Access Compliance Report

Public Rights-of-Way

(Curb Ramps)

Intersection ID: 14272	Main Street: BROOKHILL_RD	Cross Street: VILLAGE_CT	Location: NE
ADA ID: 21D541DEA688	Ramp Type: PerpDiag	Initial Pass/Fail: Fail	Overall Compliance: No
		Severity Score: 25

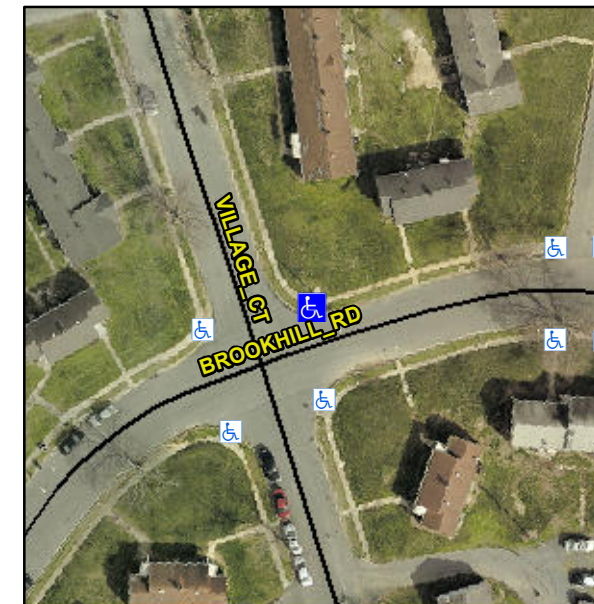
Not Found, R304.2.2

Compliance	Description	Data	Compliance	Description	Data
N/A	Ramp Length (in)	41.0	No	Ramp Slope (%)	14.4
Yes	Ramp Width (in)	48.0	Yes	Ramp XSlope (%)	1.9
N/A	Flare Type LT	N/A	N/A	Flare Type RT	N/A
N/A	Flare Slope LT (%)	N/A	N/A	Flare Slope RT (%)	N/A
N/A	Flare Traversable LT?	N/A	N/A	Flare Traversable RT?	N/A
N/A	Landing Length (in)	N/A	N/A	DWS Provided?	N/A
N/A	Landing Width (in)	N/A	N/A	DWS Contrast?	N/A
N/A	Landing Slope (%)	N/A	N/A	DWS Length (in)	N/A
N/A	Landing X Slope (%)	N/A	N/A	DWS Full Width?	N/A
N/A	Landing Curb? (Y/N)	N/A	N/A	DWS Offset (in)	N/A
N/A	Shared Landing?	N/A			
N/A	Gutter Ponding?	N/A	N/A	Gutter Slope (%)	N/A
N/A	Gutter Lip Ht (in)	N/A	N/A	Gutter X Slope (%)	N/A
N/A	Painted X Walk1?	No	N/A	Painted X Walk2?	No
	X Walk 1 Direction	To W		X Walk 2 Direction	To S
N/A	X Walk 1 Width (in)	N/A	N/A	X Walk 2 Width (in)	N/A
	X Walk 1 Slope (%)	2.5		X Walk 2 Slope (%)	4.8
	X Walk 1 X Slope (%)	4.2		X Walk 2 X Slope (%)	0.5

Remove & Replace Curb Ramp With Two New Directional Ramps or Equivalent.
